**TYRONE TOWNSHIP
REGULAR BOARD MEETING AGENDA
JANUARY 18, 2022 - 7:00 P.M.
(810) 629-8631**

Lake Urban Crossing PUD Preliminary Site Plan

**Subject: Agenda Request, Lake Urban Crossings Preliminary PUD Plan
Recommendation for Approval**

PRELIMINARY SITE OPEN SPACE PLAN LAKE URBAN CROSSINGS

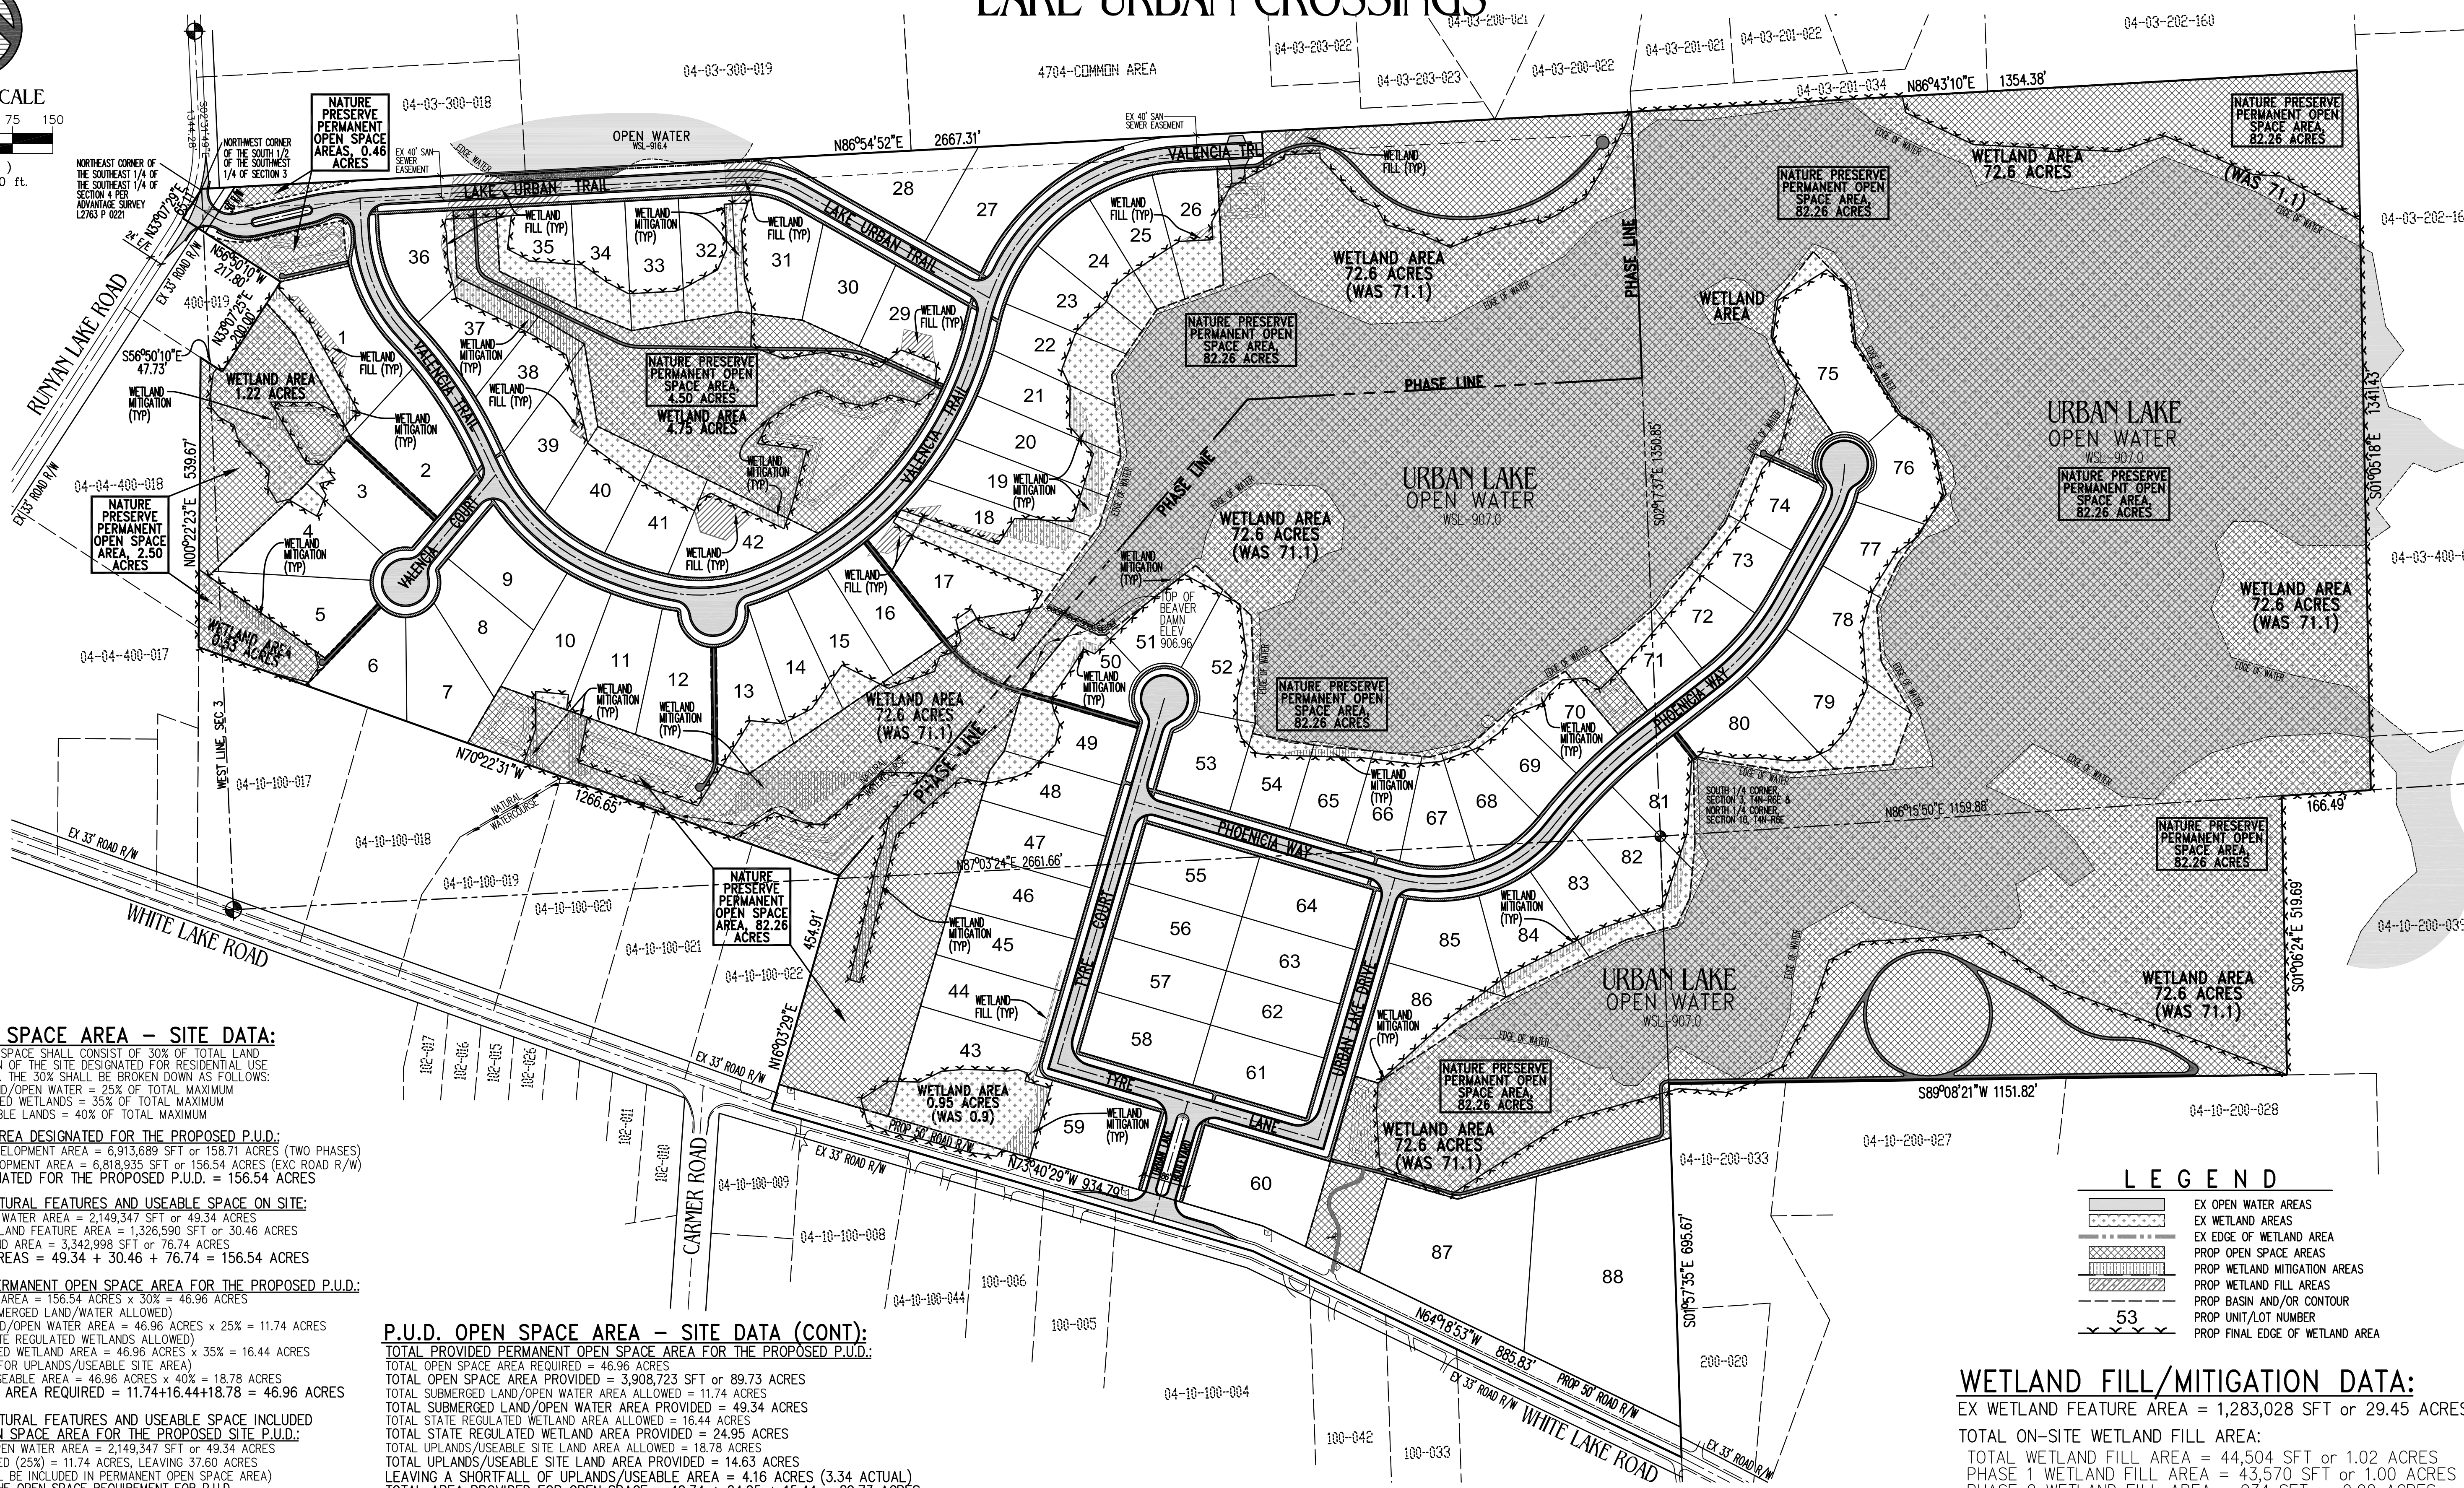
The calculations on Sheet P-5 states the open space would include 49.34 acres of submerged land/open water, 24.95 acres of state-regulated wetland, and 15.44 acres of upland. Based on the limitations above, the submerged lands and wetlands would be allowed to contribute a maximum of 28.17 acres. With the upland, a total of 43.61 acres of open space would be provided, according to the Zoning Ordinance, roughly 3.35 acres short of the required open space. (The calculations on Sheet P-5 incorrectly limit upland to 40% of the required open space, but there is no limit on upland contribution.)

9. *Open space calculations on Sheet P-5 should be corrected. (There is no maximum contribution of upland area and additional details about stormwater basins.)*

PRELIMINARY SITE LANDSCAPING PLAN LAKE URBAN CROSSINGS

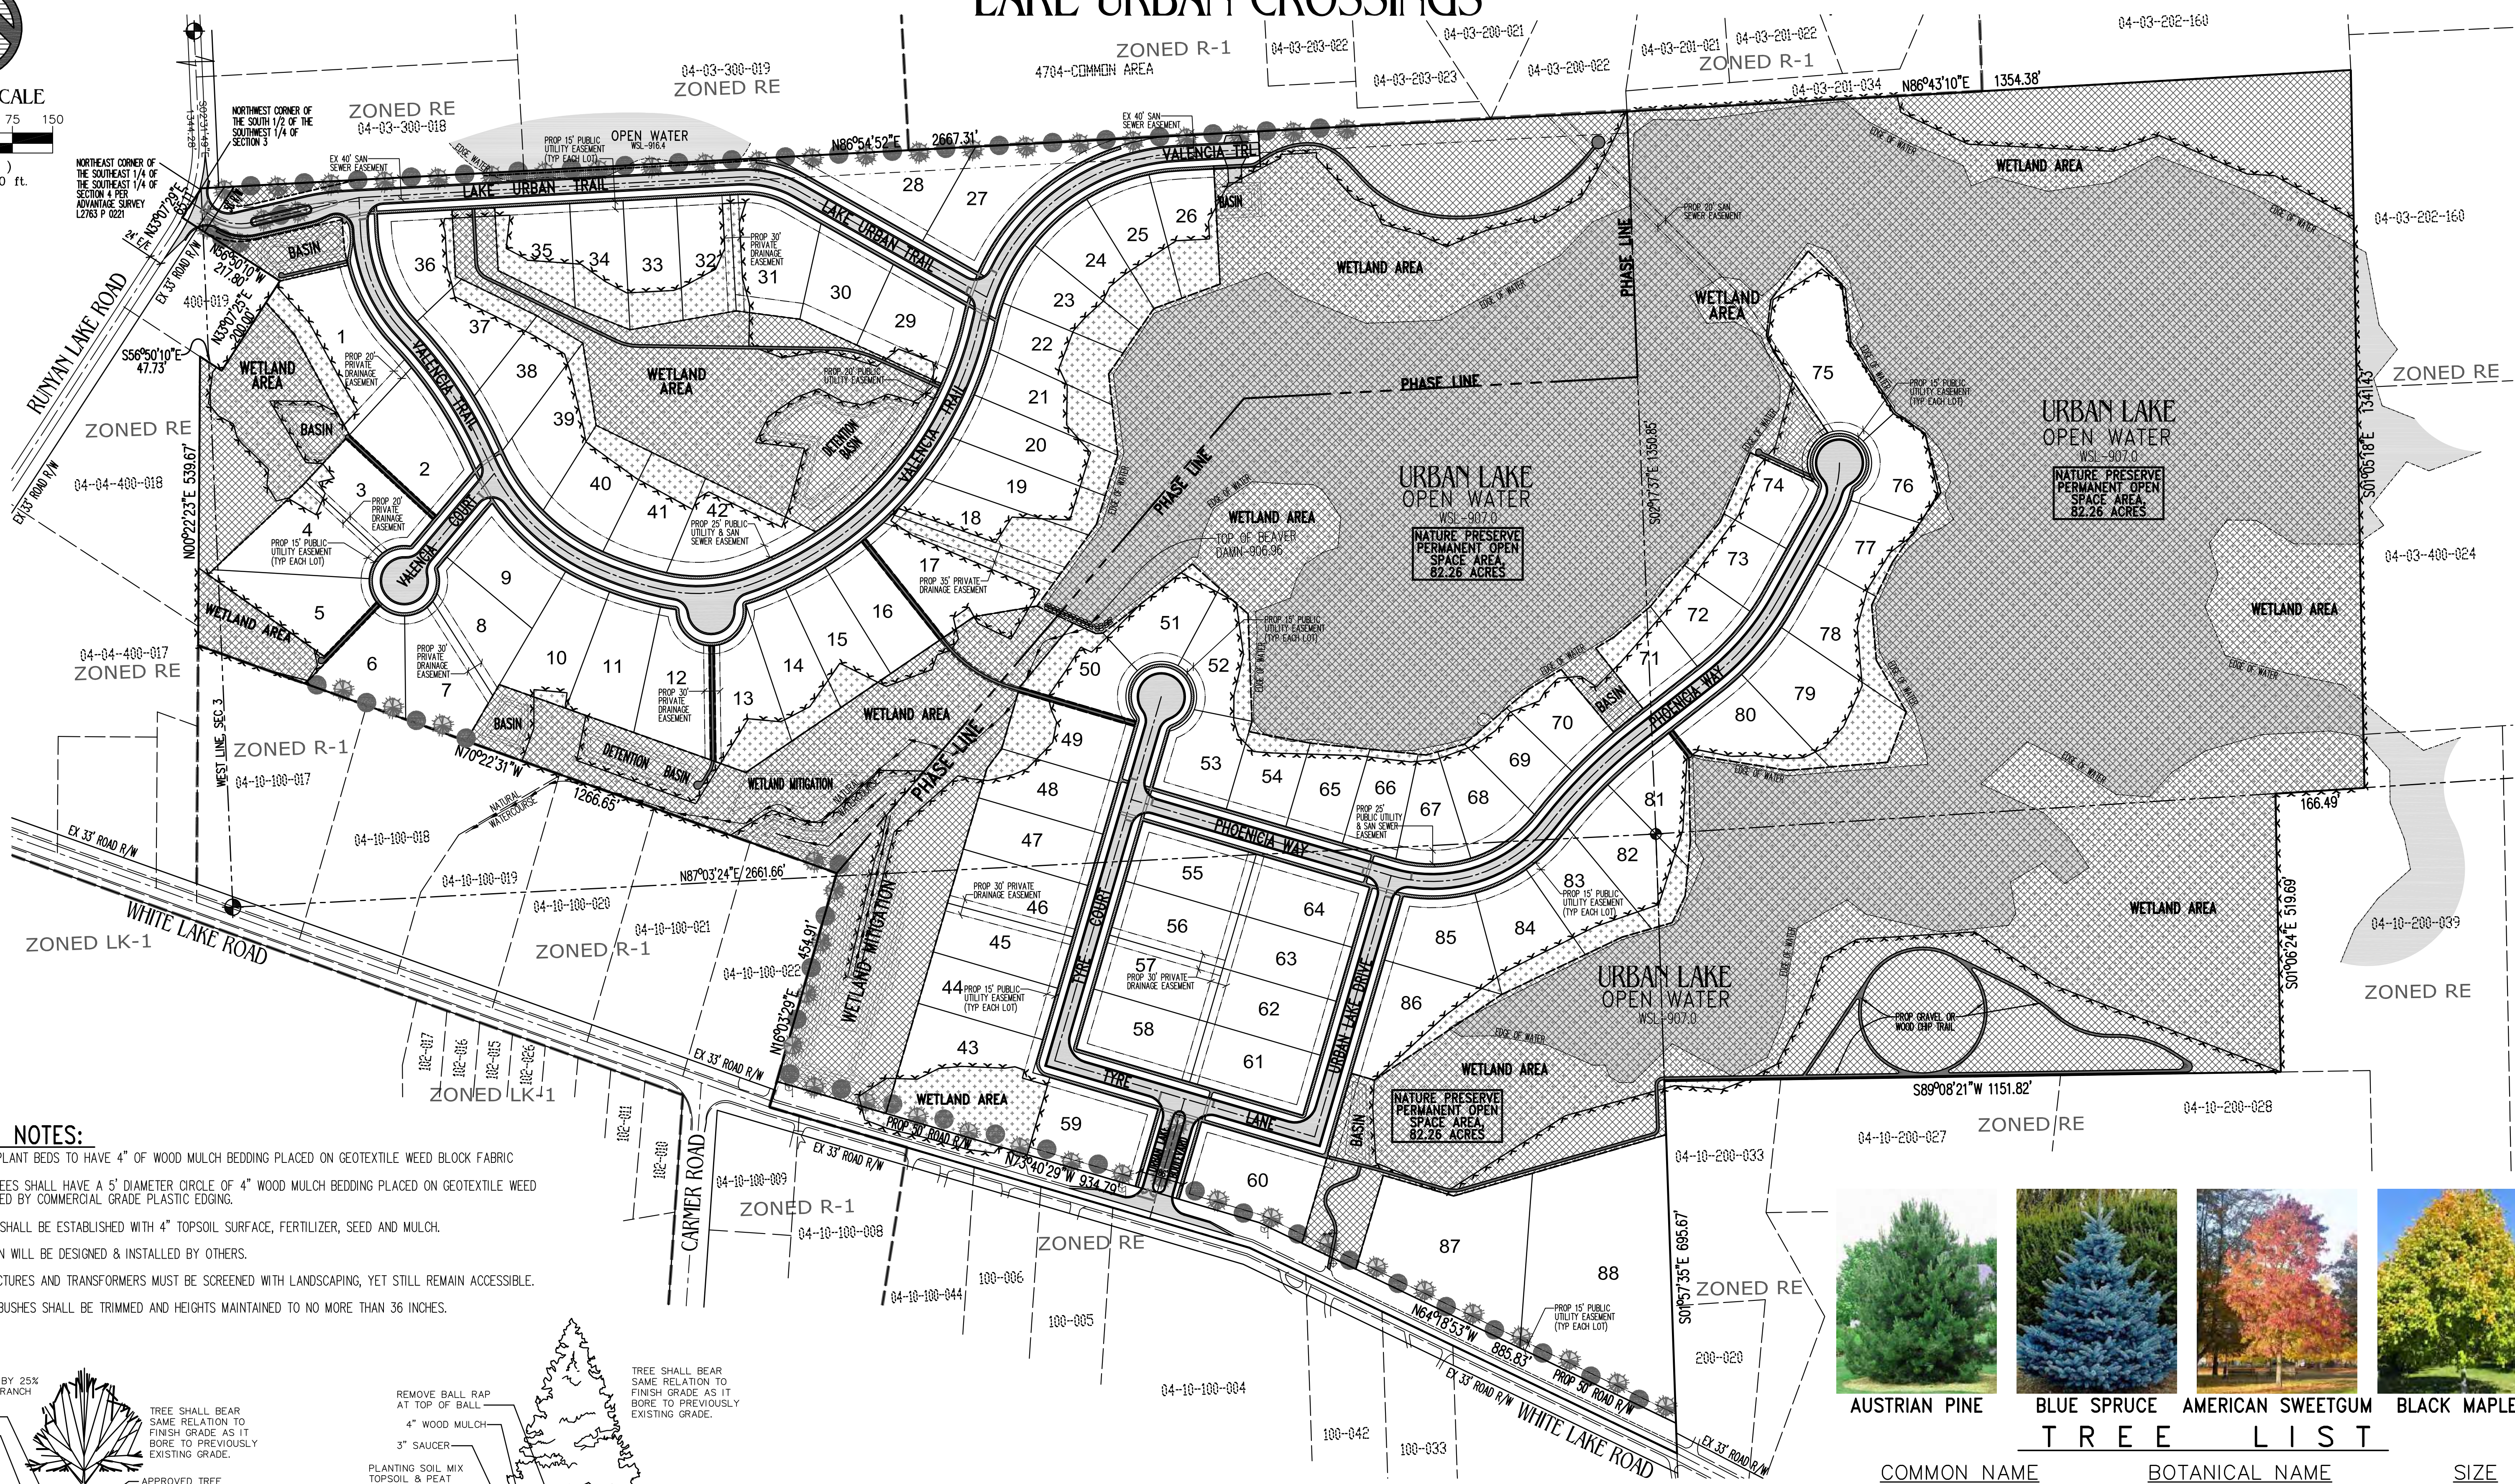
Comments: *A landscaping plan has been submitted as Sheet P-6. It shows the rough location of proposed plantings and the types of trees to be planted.*

PRELIMINARY LIMITS OF CONSTRUCTION PLAN LAKE URBAN CROSSINGS P.U.D.

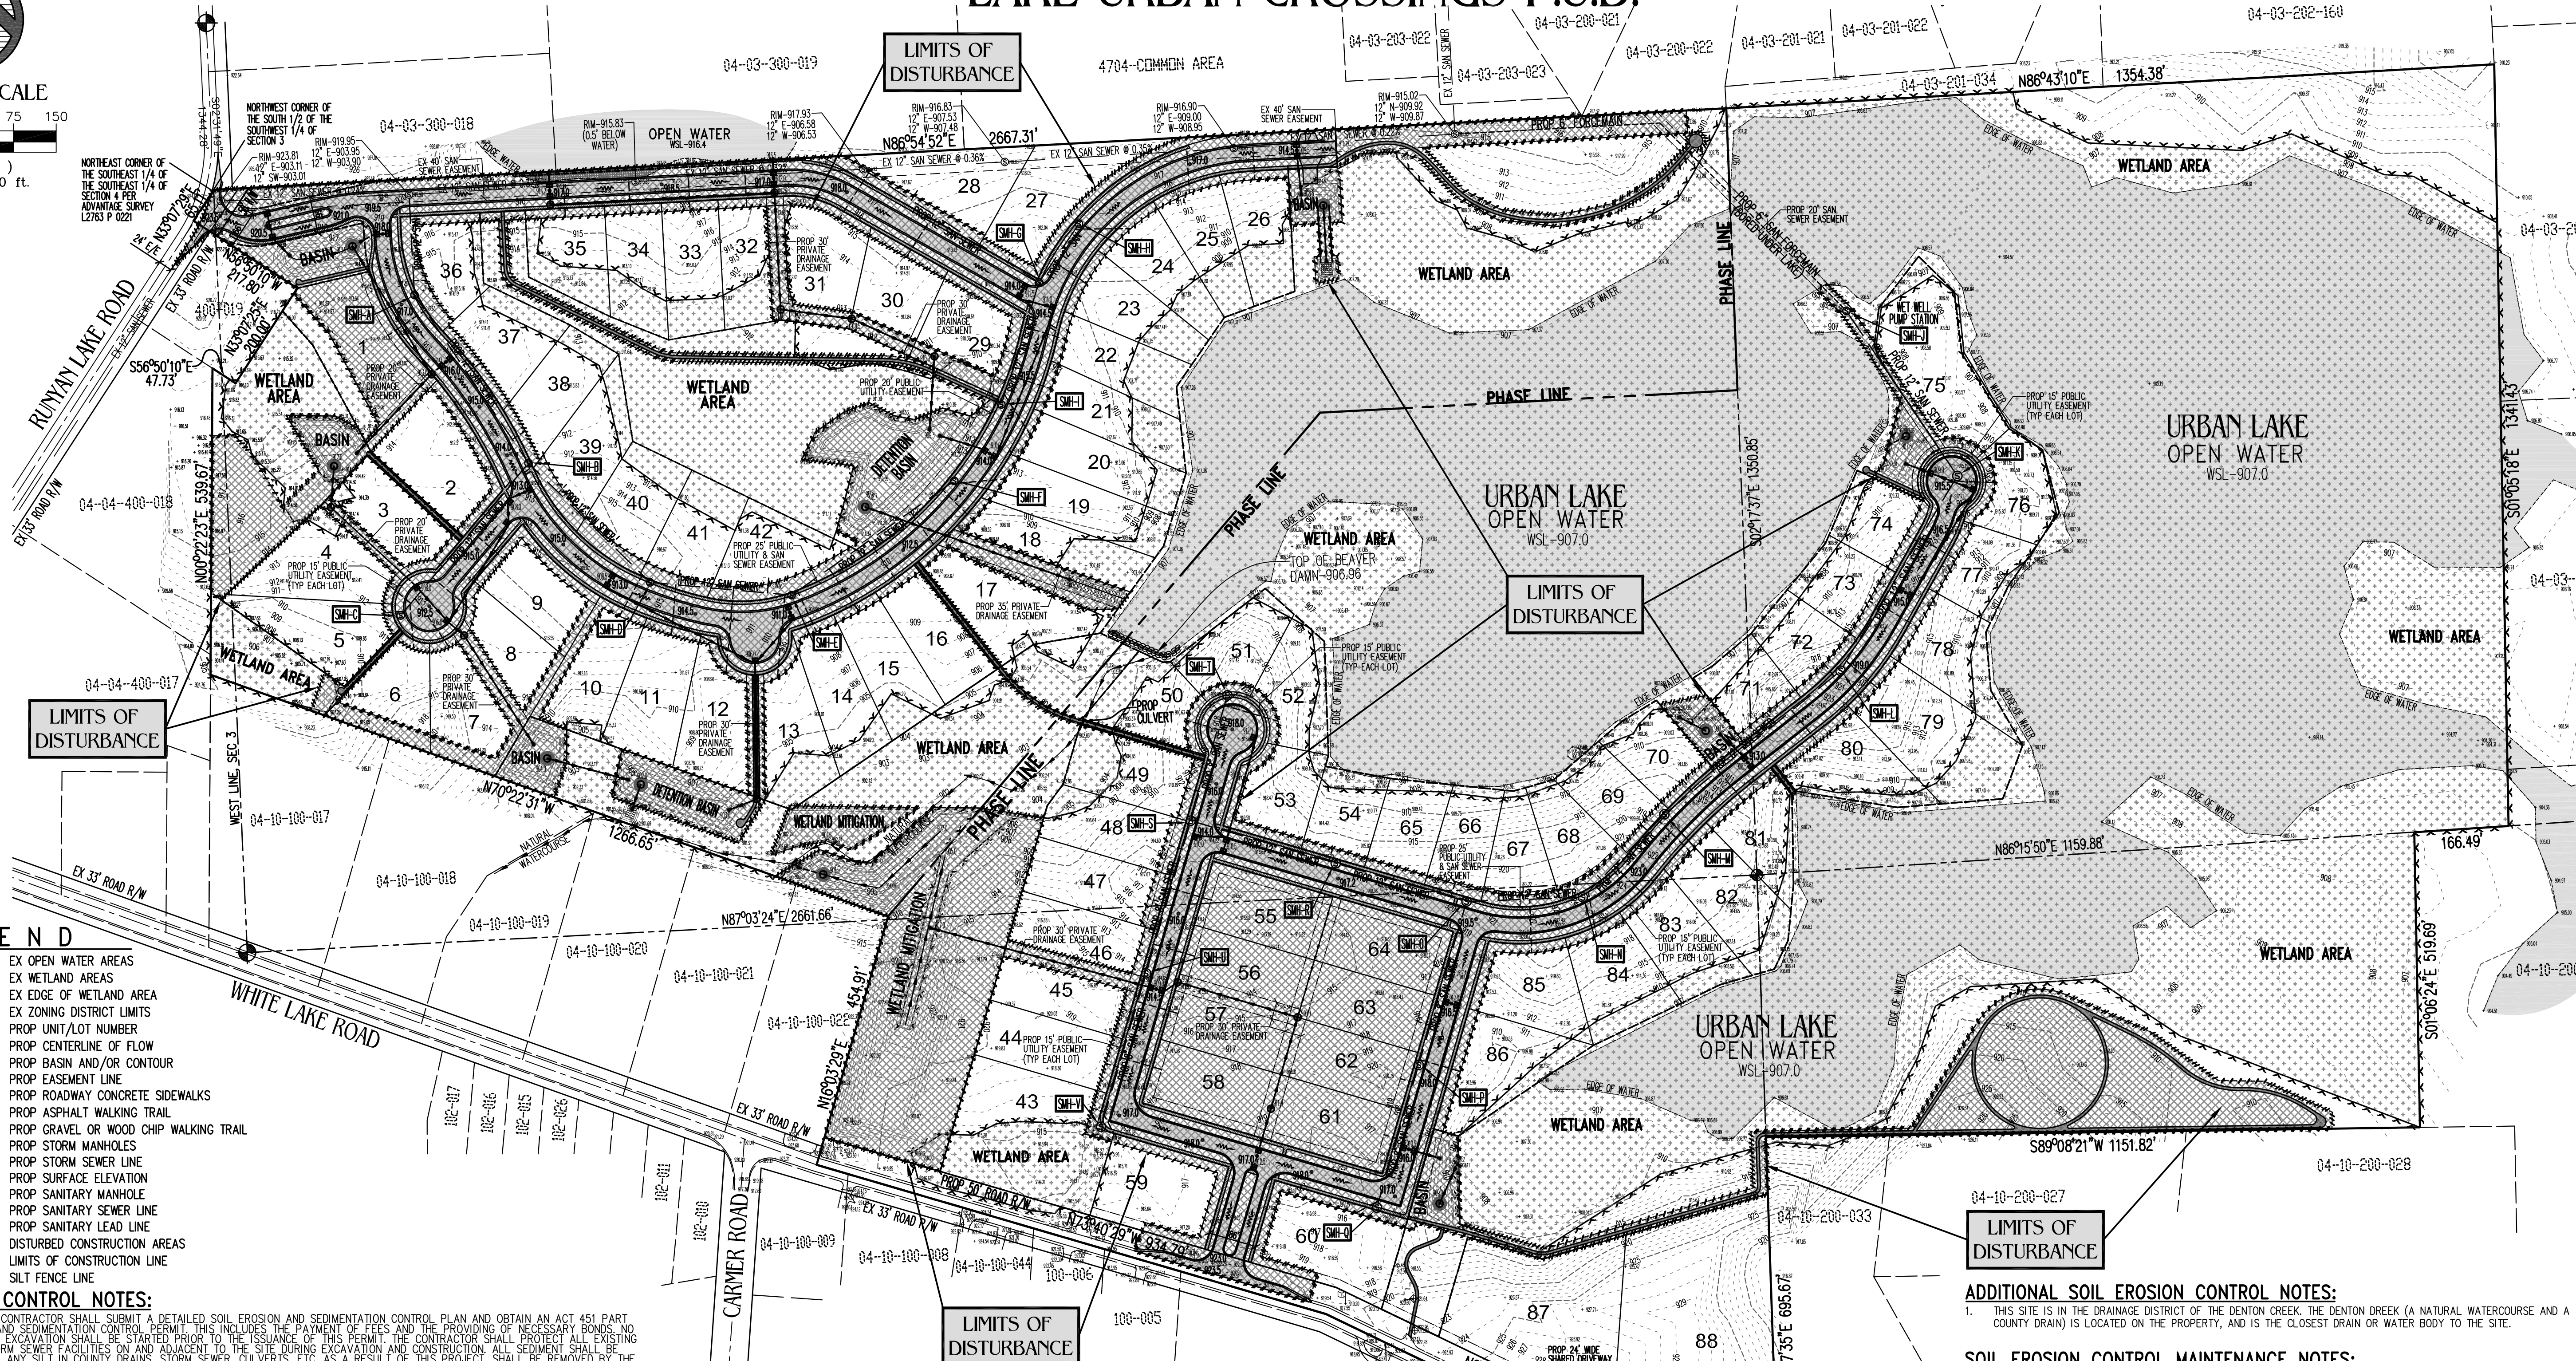
Comments: *The preliminary plan for the proposed planned unit development shows the limits of disturbed areas on Sheet P-7. This area will include some grading and filling adjacent to neighboring properties, but it is not clear that the proposed work would create a negative impact.*

Comments: *The proposed planned unit development includes areas that would be preserved in their natural state or with little disturbance. Sheet P-7 shows the limits of disturbed areas.*
